Village of Arlington Heights
Plan Commission
Board Room
Arlington Heights Village Hall
33 S. Arlington Heights Road
Arlington Heights, IL 60005
September 9, 2015
7:30 PM

- A. Xilin Adult Day Care - 145 E. Algonquin Rd. - PC#15-011
Land Use Variation
- B. Olive-Mary Stitt School - 303 E. Olive St. - PC#15-015
Special Use for a School
- C. Ivy Hill School - 2211 N. Burke Dr. - PC#15-016
Special Use for a School

OLIVE-MARY STITT SCHOOL

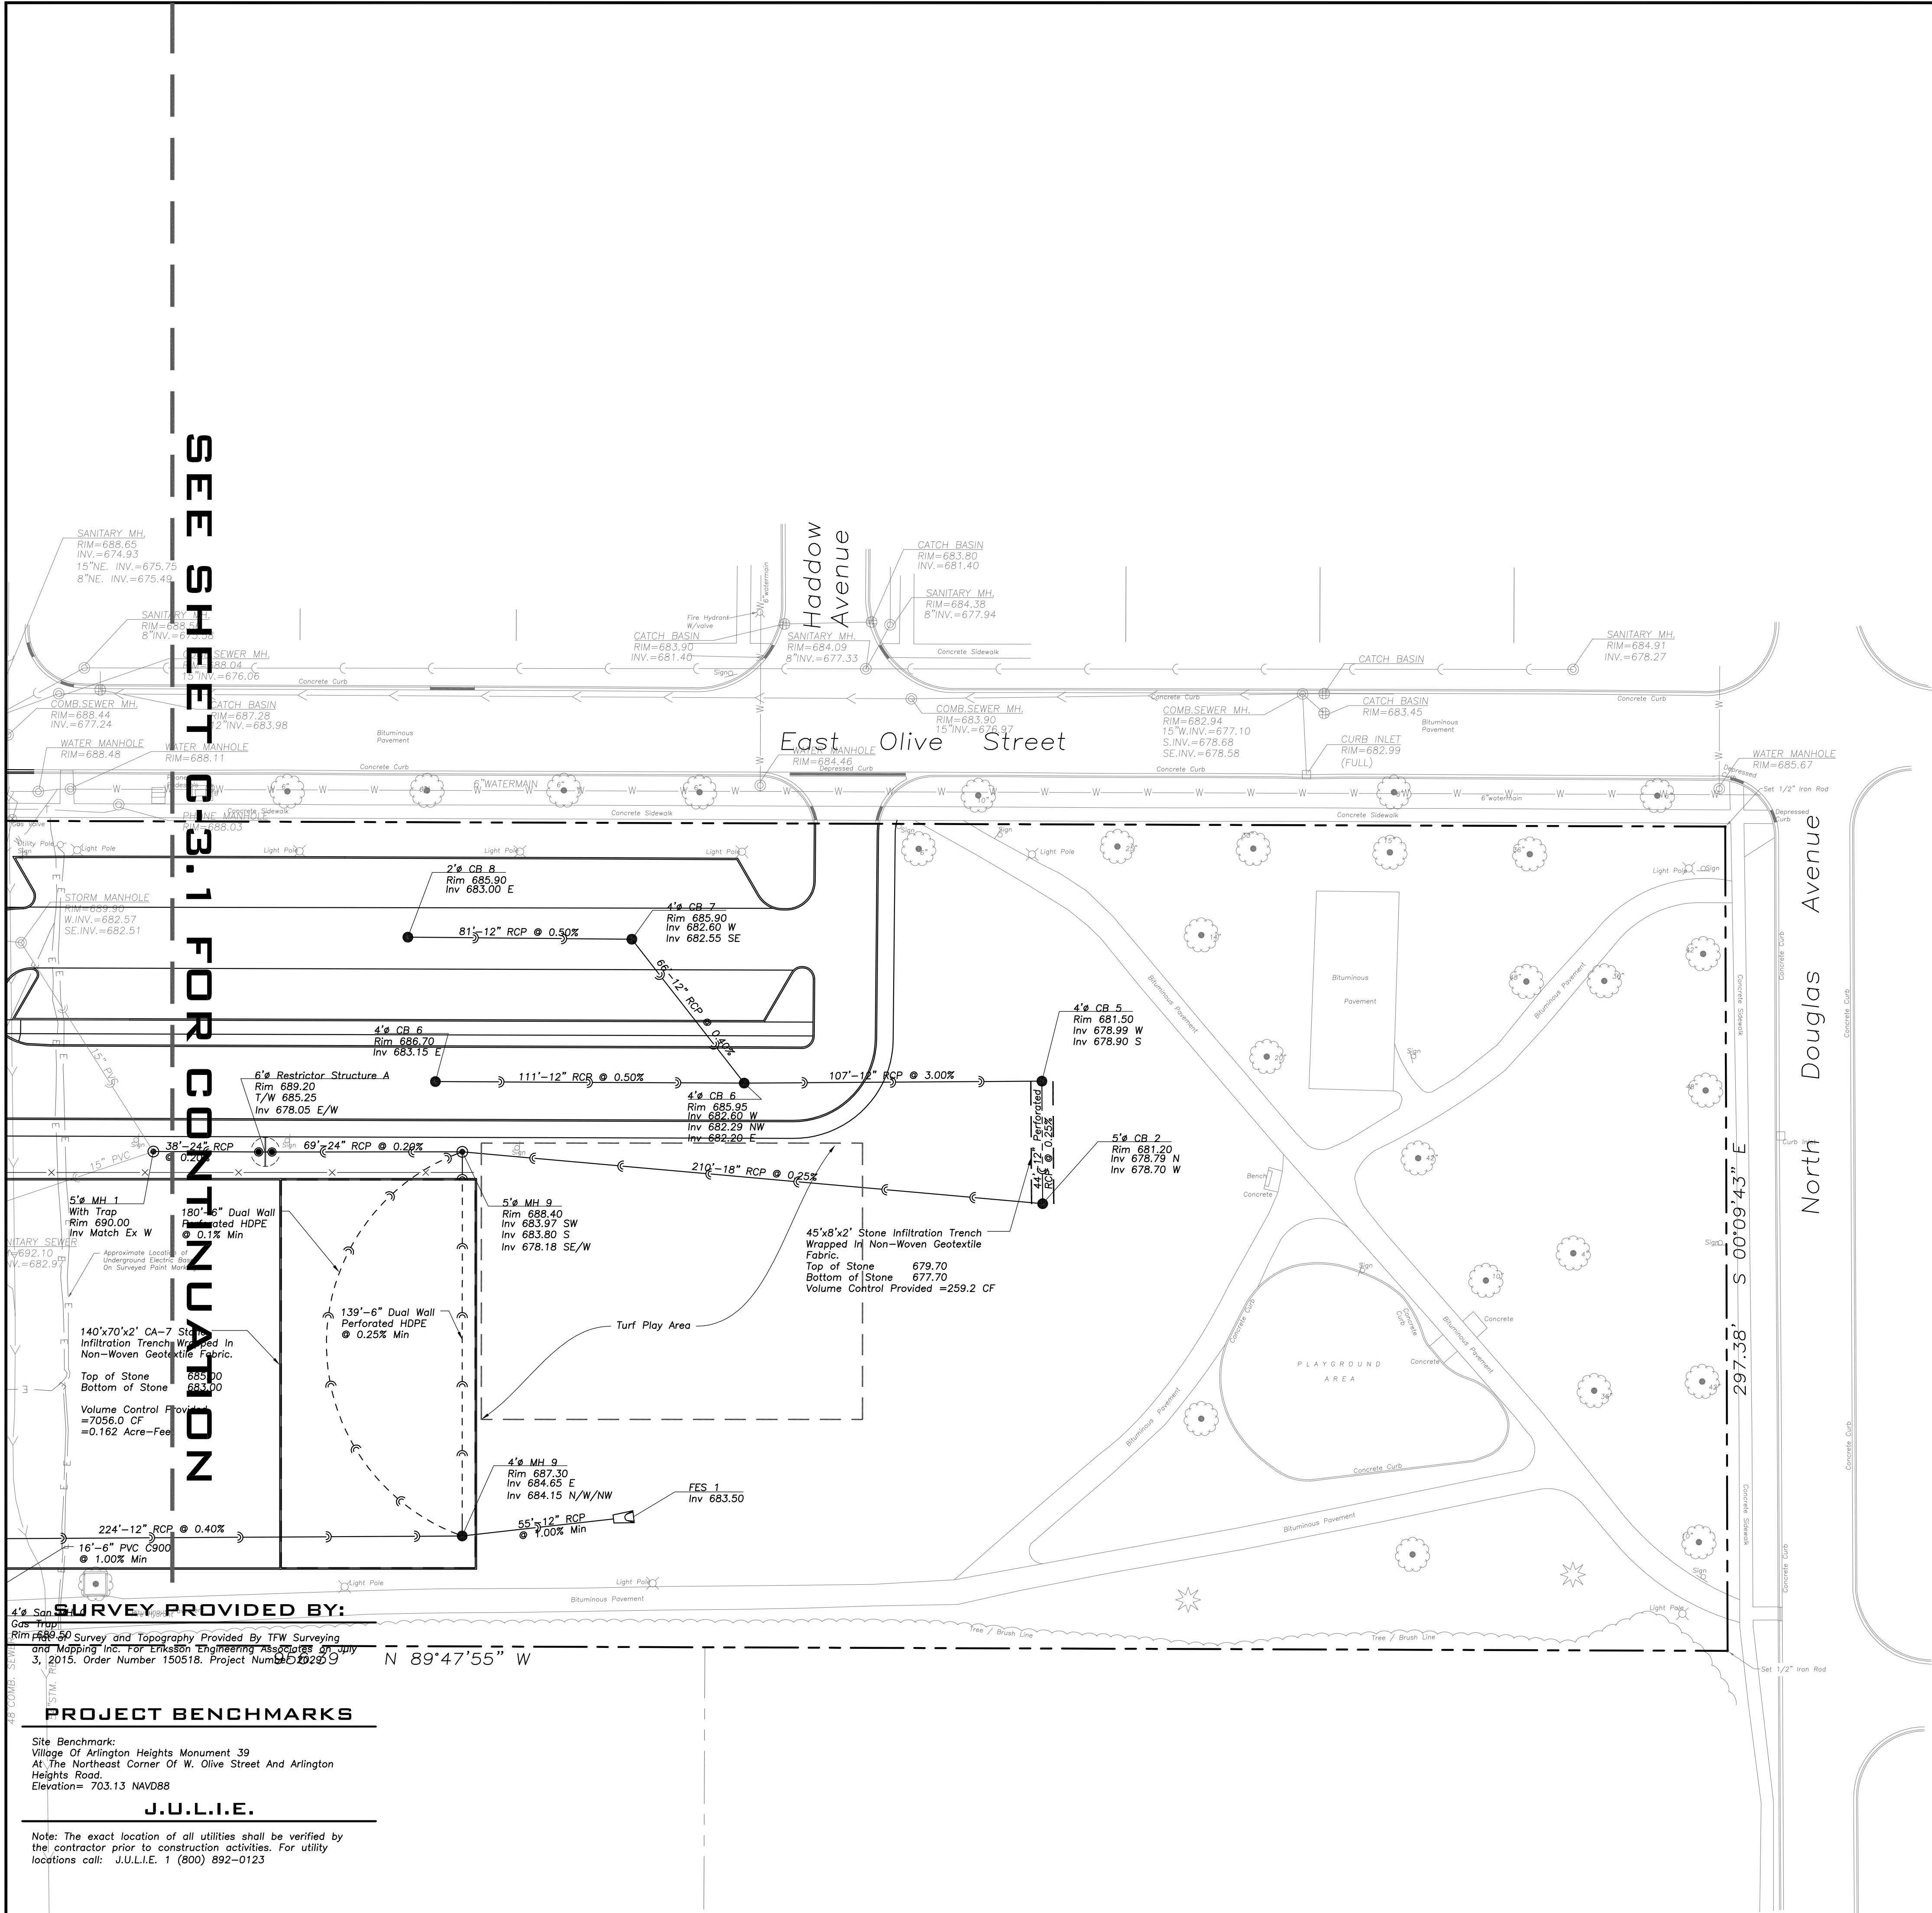
22. Sheet C-3.1: The sanitary sewer connection shown for the west addition is not acceptable. As was previously communicated, portions of the existing sanitary sewer within the public easement are not public but privately maintained. The nearest public sanitary manhole is immediately northeast of the Clarendon Street cul-de-sac behind the sidewalk. On the drawing, the manhole is labeled as an existing sanitary manhole, Rim=691.73, 8" Inv=685.07.

23. Sheet C-3.1: Provide conflict elevations for where the new sanitary sewer from the east building addition crosses the existing 10" public water main in the vacated Belmont Avenue corridor. Similarly, provide conflict elevations for the proposed storm sewer where it crosses the existing utilities. The existing sanitary service is shown to connect to the storm relief sewer...Is this shown correctly?

Sheet No:
C-4.1

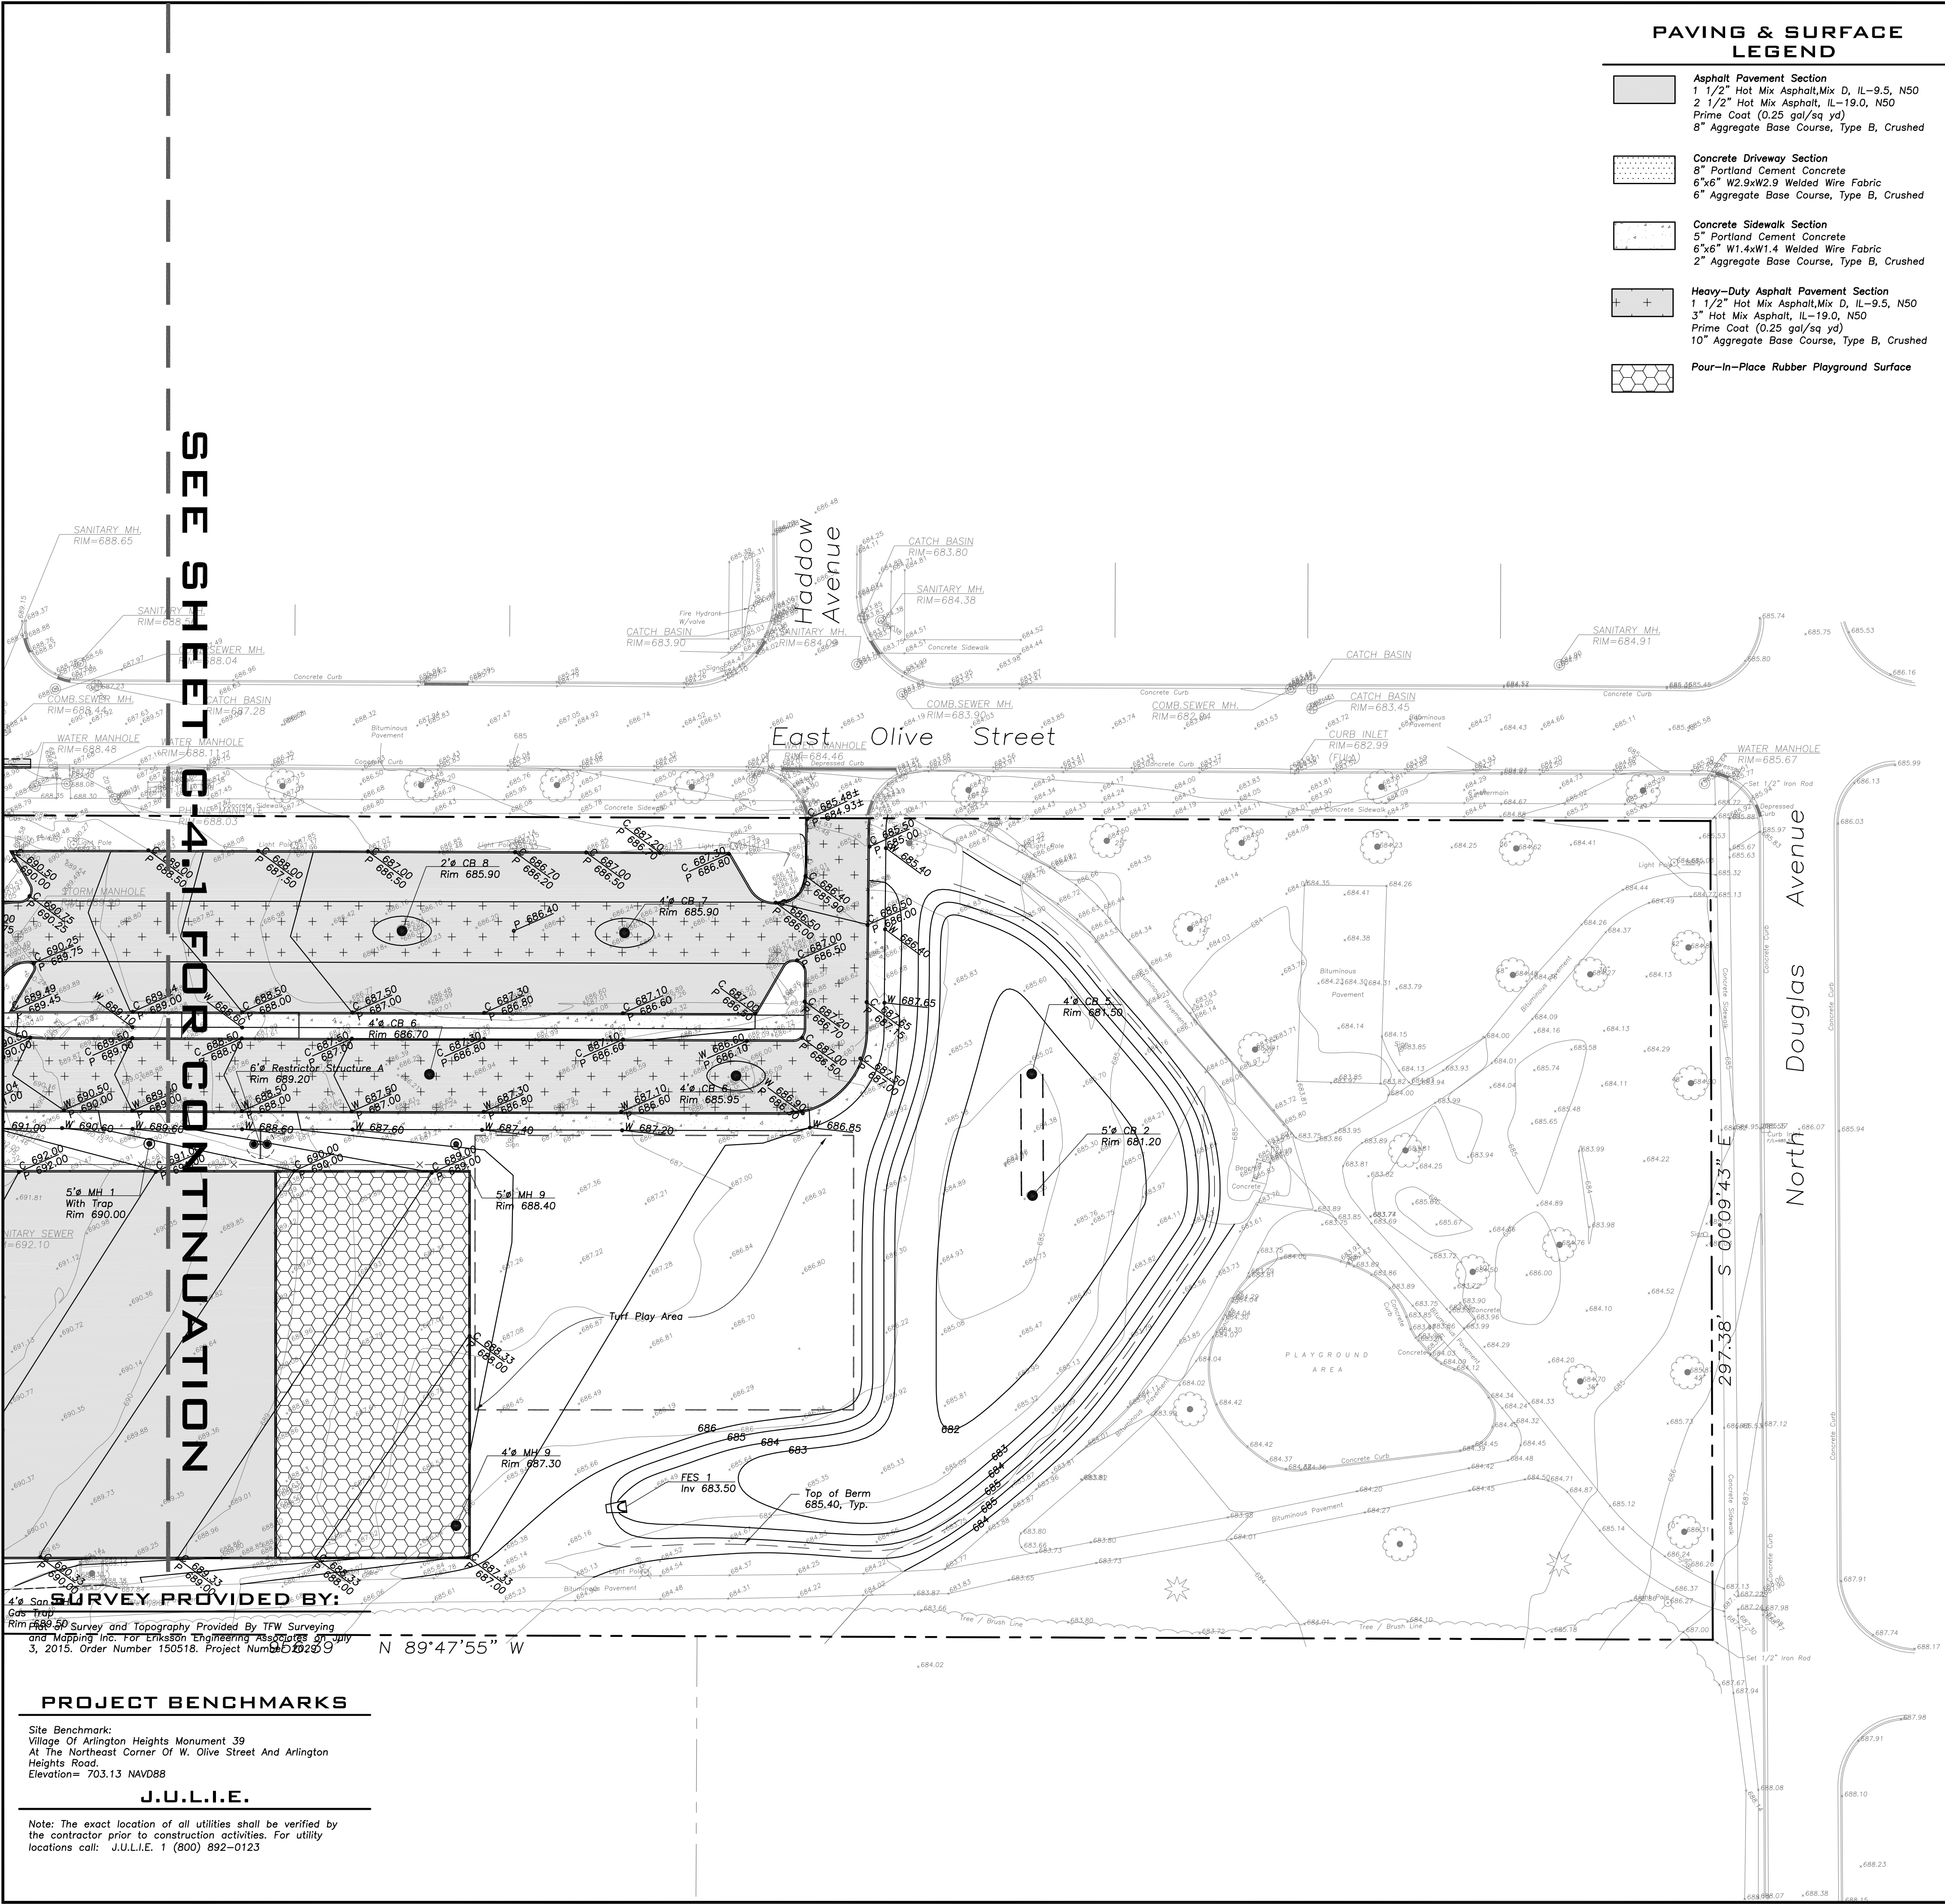
24. Sheet C-4.1: The grade at the south corner of the new gym drops off steeper than 5:1 along the property line and any runoff from the slope will be directed to the neighbor's lot. Review this area for re-grading.

C-4.2

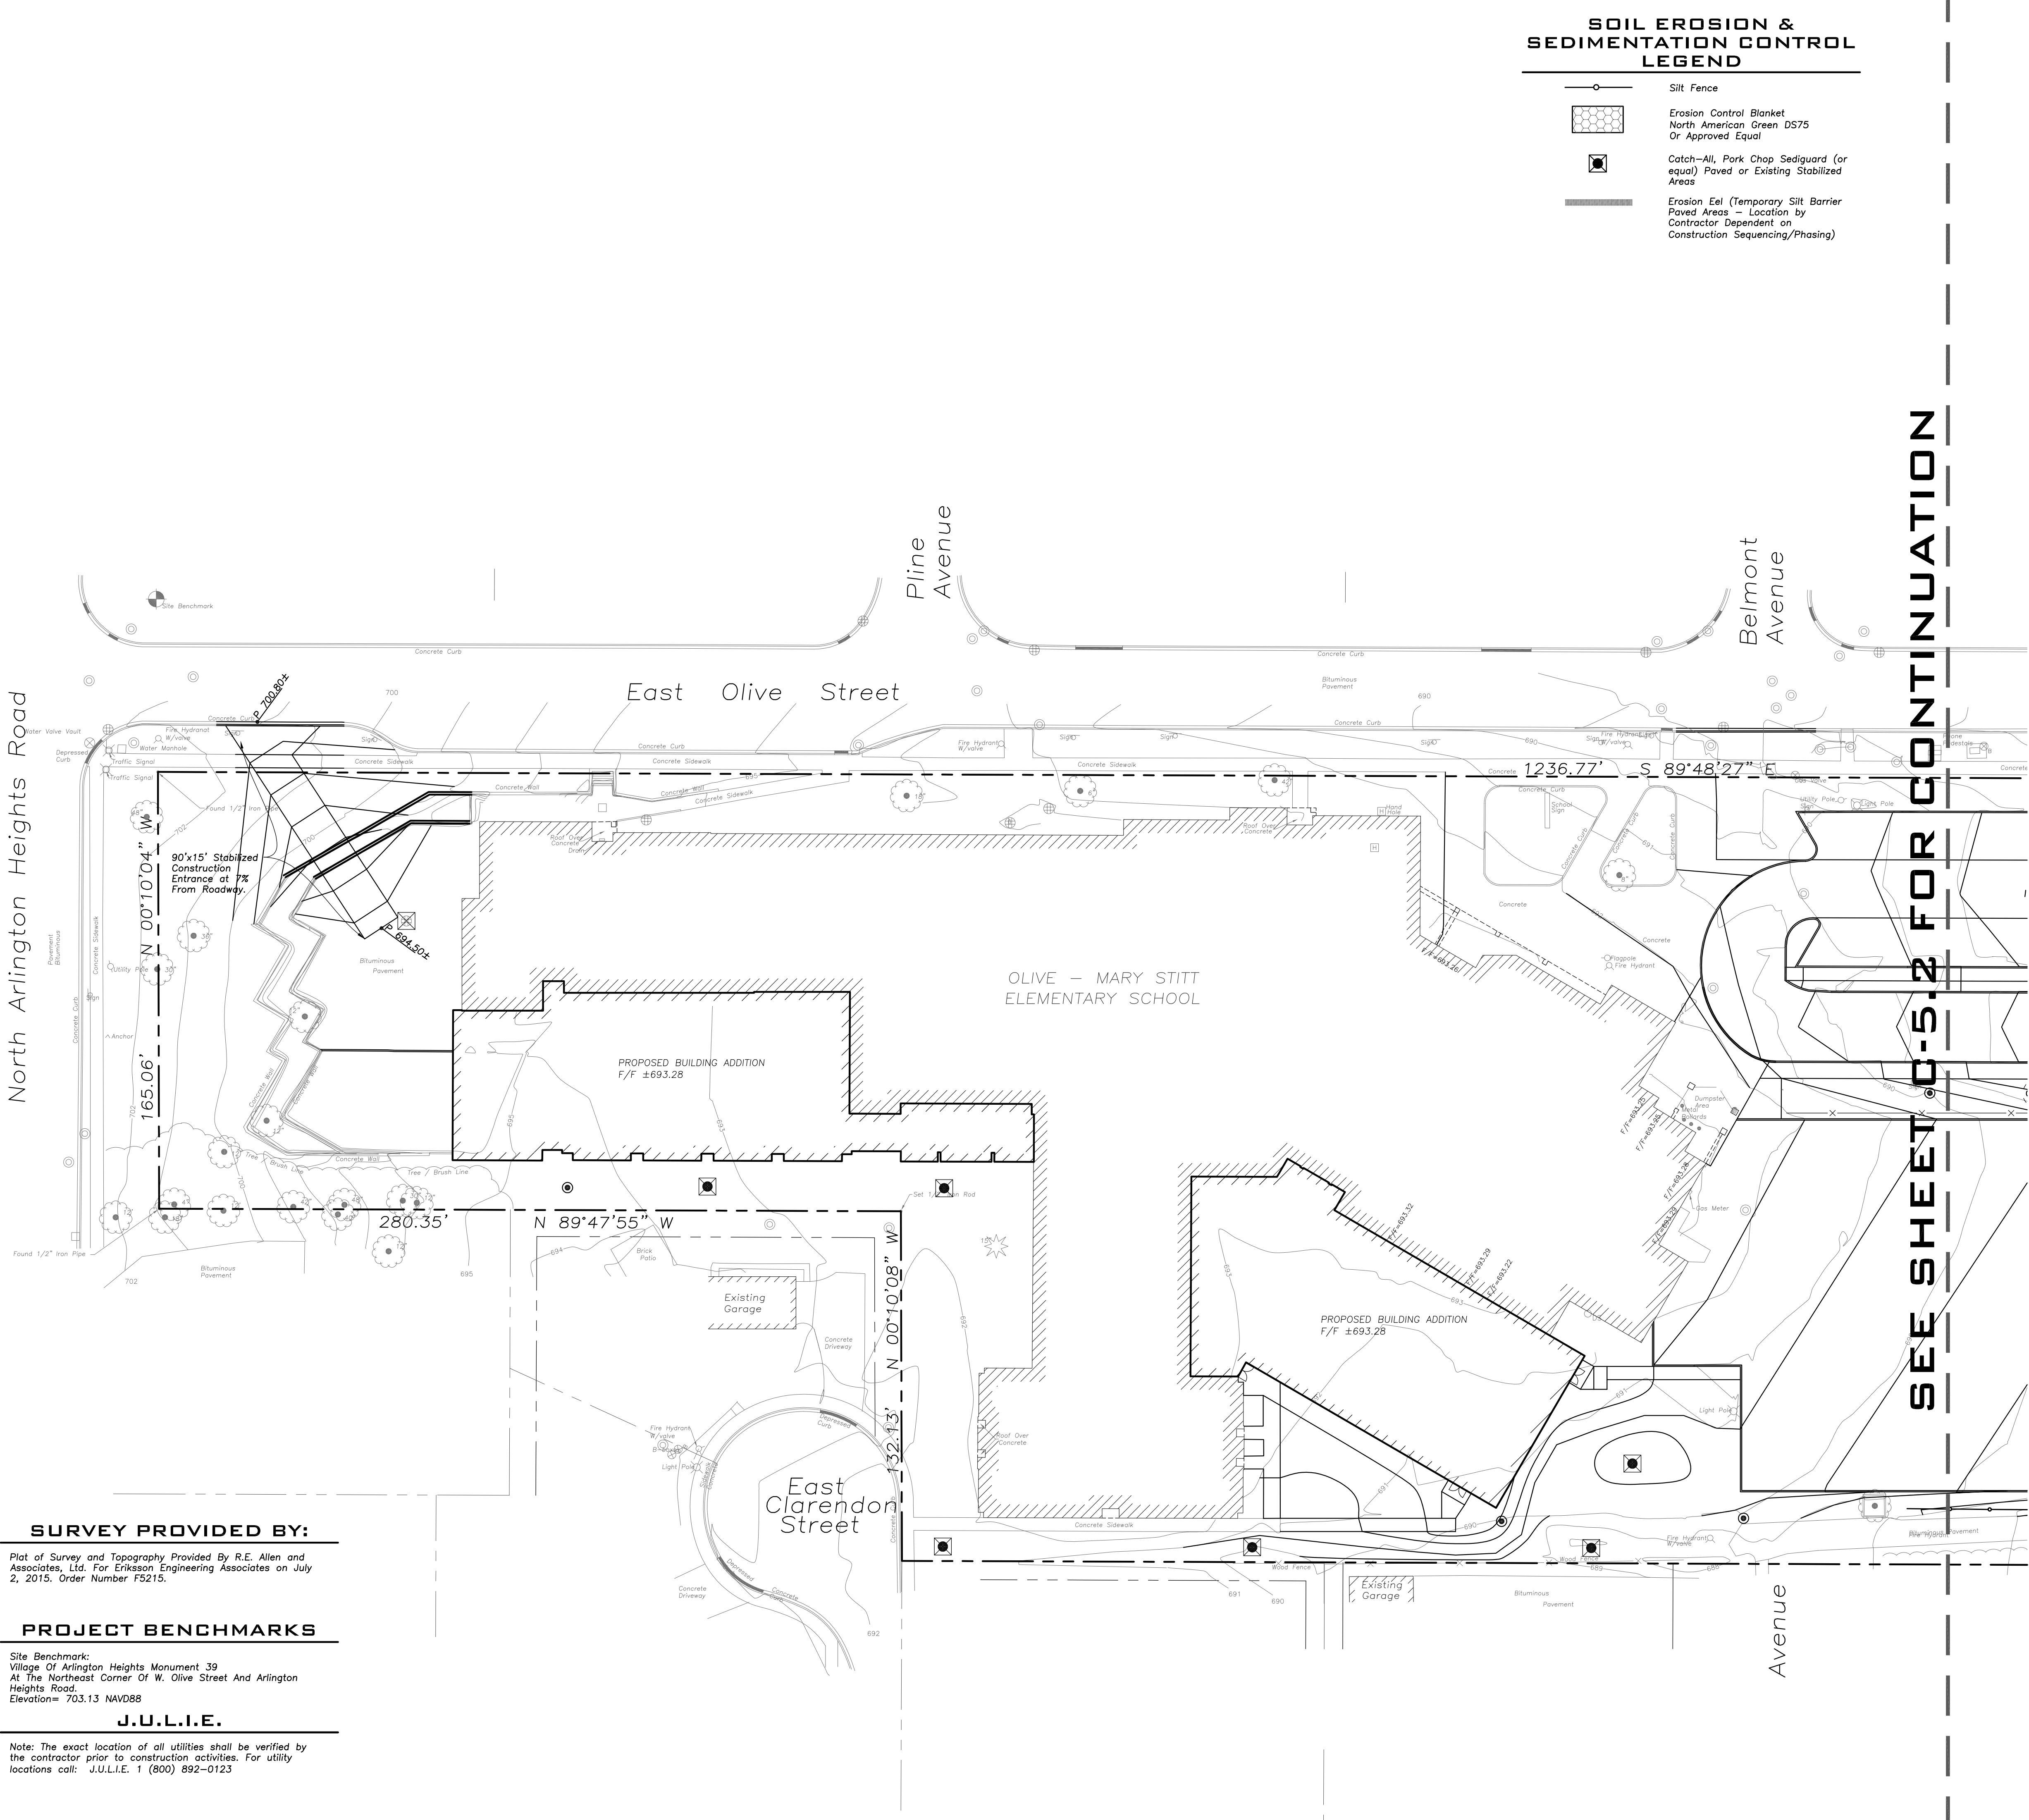
25. Sheet C-4.2: The detention basin is shown with 4:1 slopes. Minimum Village requirement is 5:1.
